MAL No. - N° de LAM
MAL - G255 Rev. 3

MODIFICATION ACCEPTANCE LETTER (MAL) FOR Approved Meters and Devices

Positive Displacement Gas Diaphragm Meter

AG-0393

Figure 1

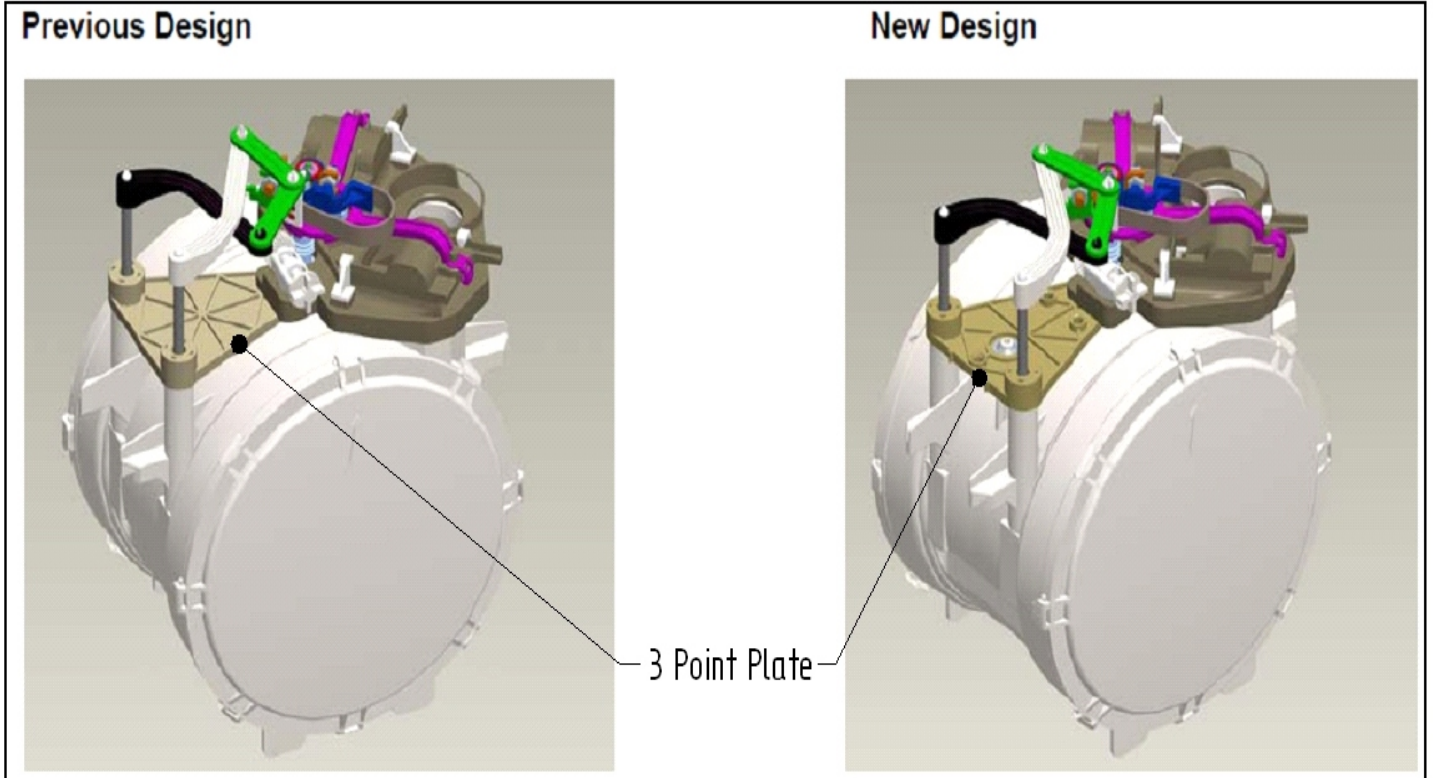
The purpose of revision 2 was to acknowledge and accept as being included in the scope of the Notice of Approval the use of a modified three point plate installed on the top of the centre module. Refer to figure 1.

La révision 2 vise à reconnaître et à accepter que l'utilisation d'une plaque à trois points modifiée, installée sur la partie supérieure du module central, fasse partie du domaine d'application de l'avis d'approbation. Voir la figure 1.

Figure 4

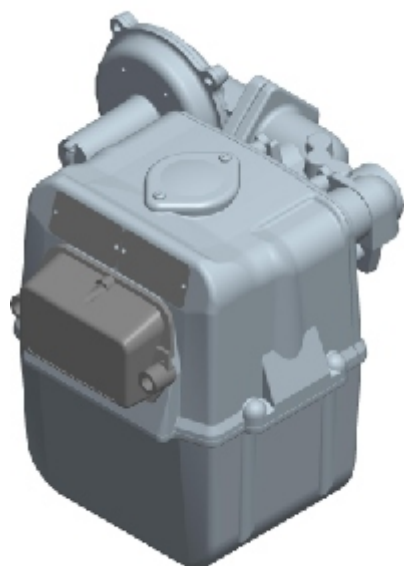
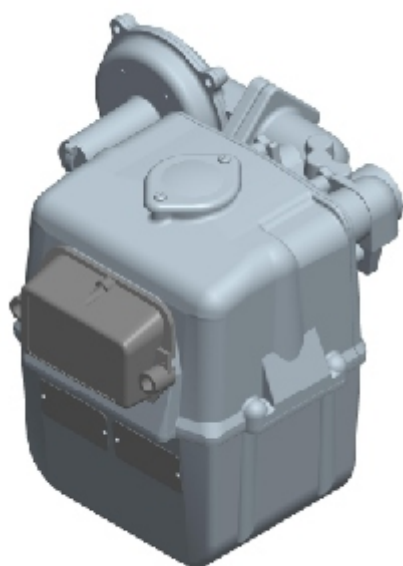
The same change that was identified by revision 1 to this MAL for the 6 inch on centre top inlet and outlet version of the Metris meter can now be applied to the RM and MB versions. This change permits the meter badges to be affixed to the meter body below the front index on the bottom casting. Refer to Figure 3. Additionally, minor changes were made to the top casting to remove the area previously needed for the badge installation and to improve rounding of the casting for water-shedding. There is no change to the dimensions of the top casting as a result of these minor modifications. Refer to Figures 4 and 5.

Il est maintenant possible d'appliquer aux versions RM et MB le même changement que celui décrit dans la révision 1 de la présente LAM, pour la version entrée et sortie à 6 po entraxe sur le dessus du débitmètre Metris. Ce changement permet de fixer les plaques signalétiques des compteurs sur le devant du boîtier moulé du compteur, juste en-dessous de l'indicateur. Voir la figure 3. En outre, des changements mineurs ont été apportés à la partie supérieure du boîtier moulé en vue d'enlever la partie auparavant nécessaire pour installer la plaque signalétique et améliorer l'arrondi du boîtier moulé pour l'élimination de l'eau. Les dimensions de la partie supérieure du boîtier moulé n'ont pas été changées à la suite de ces légers changements. Voir les figures 4 et 5.
